AGENDA ITEM # 2

TO: Design Review Commission
FROM: Eliana Hassan, Assistant Planner
SUBJECT: APPL19-0004 – 626 Torwood Lane

APPL19-0004 – 626 Torwood Lane

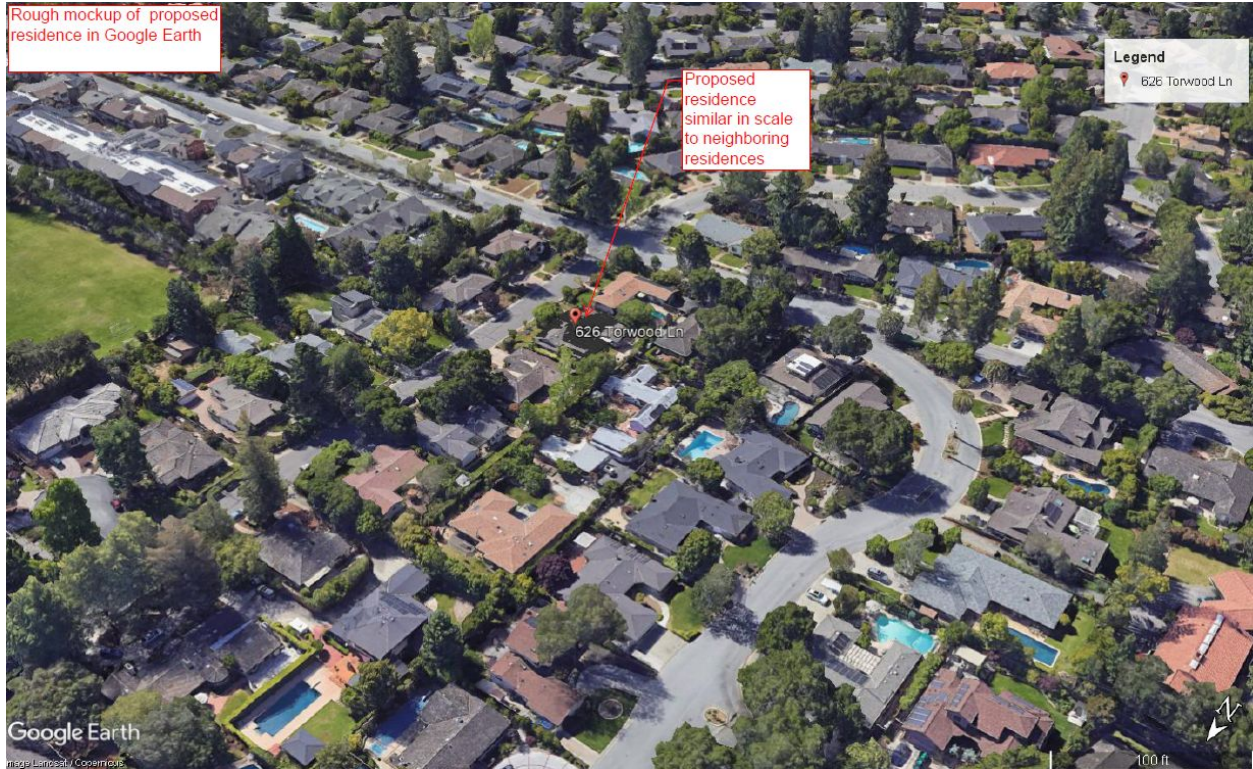
We have included some images of the latest proposed design inserted into Google Earth to show its relation to the neighborhood. These images help to show the proposed residence's compatibility with the neighboring structures. They also show that the overall size of the proposed residence is not that different from the existing residence. The existing residence appears even taller in certain areas.

A specific cause of concern for Staff has been a perception of bulk of the entryway.

- The entryway is very similar to our next door neighbor's (640) and isn't much taller. 640, too, is located on a slight slope upwards from the street.
- We have made a series of changes to our original design to address the committee's concerns. In particular, we have reduced the roof overhang by 3' and have eliminated the 3' wing walls to match the style of 640. We have further set back the entire entry feature by 1'. We believe that the changes have significantly reduced the "appearance of bulk", especially when compared to 619 and 640, as shown in the images below.

626 (after moving the front entry wall back by 10'--note difficulties entering BR4 and Den)

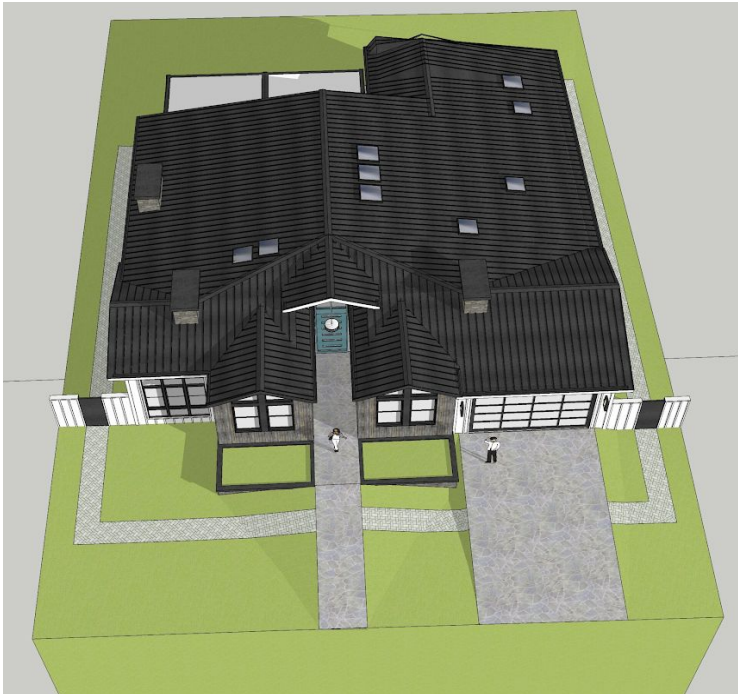
Our understanding is that Staff is still not willing to approve the design unless we make more “drastic changes” such as moving the front entry wall back 10’ creating a “tunnel” entryway (which would require a major redesign of our floor plan so that one can enter the den as well as bedroom 4) or lowering the ridge of the entry feature so that it is in line with the other front elements (which in our opinion destroys the aesthetics of the exterior and interior design as it eliminates a continuous ridge that flows from the front door to the rear of the house).

The following images show our design if the front entry wall were set back by 10':

We feel that these requests are both detrimental to our design and not beneficial to the neighborhood, especially when comparing our proposal to existing homes in the neighborhood. Even more worrisome, however, was feedback that even these changes may still not be enough to approve the design.
